PRODUCT SUPPORT BULLETIN BULLETIN NO. 366

MACHINE: Model M and M2 Ballast Regulator and Snow Clearing Machine

SUBJECT: Cab Hose Seal Kit – A0618002

Figure 1

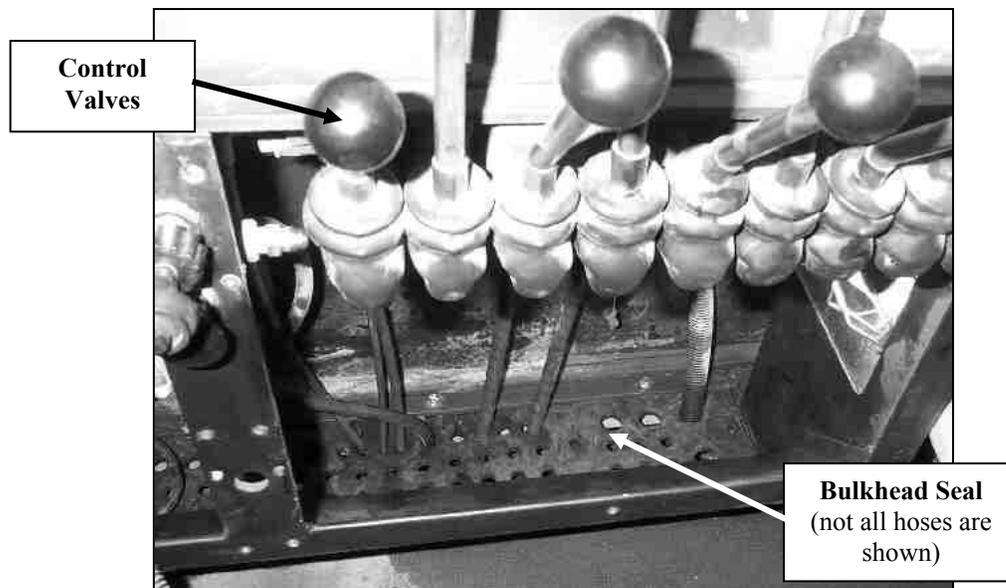
This kit has been designed to help eliminate dust from entering the cab during operation. It consists of rubber Bulkhead Seals that fit tightly around the hydraulic hoses where they enter the cab. The seals are secured to the cab floor by a steel frame. See **Figure 1**.

This kit, P/N A0618002, consists of a steel frame that must be welded to the cab floor, rubber bulkhead seals, sealant and instructions. All of the hoses to the control valves must be removed to install this kit. Installation should take about 16-24 hours.
